**TOWN OF ERIE
PLANNING COMMISSION MEETING
February 20, 2019**

SUBJECT: **Agenda # 19-100**

Review of Ranchwood Sketch Plan

PURPOSE: Review and comment on a Sketch Plan application for 220 apartment dwelling units and 64,500 square feet of commercial/office space on 6 lots.

Compliance with Town of Erie Comprehensive Plan:

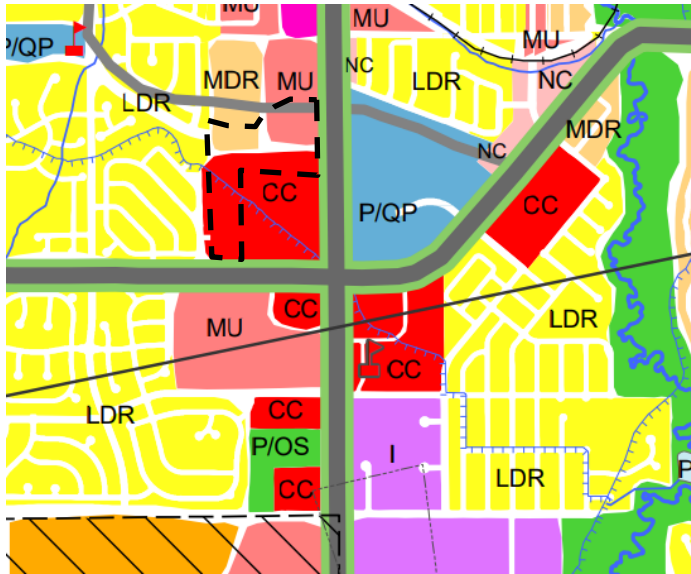
The majority of the property is designated as CC - Community Commercial on the Comprehensive Plan, Land Use Plan Map. Small areas of the site are also designated as MDR – Medium Density Residential and MU – Mixed Use. The CC designation provides a mix of general retail (e.g. grocery stores, larger retailers) and commercial services in a concentrated and unified setting that serves the local community. MDR areas should incorporate a mix of housing types and recognizable community centers such as park, recreation, and neighborhood or community commercial areas in a neighborhood setting. MU areas should provide a mix of residential at 6-12 du/ac, commercial, retail, and office uses in a compact, pedestrian-oriented environment. The submitted site plan does not meet the definition of CC and MU per the characteristics, as the Sketch Plan proposes developing most of the site as residential with some commercial land uses. The proposal would be consistent with the small area of MDR as the proposed development would provide a density of 7.67 du/ac.
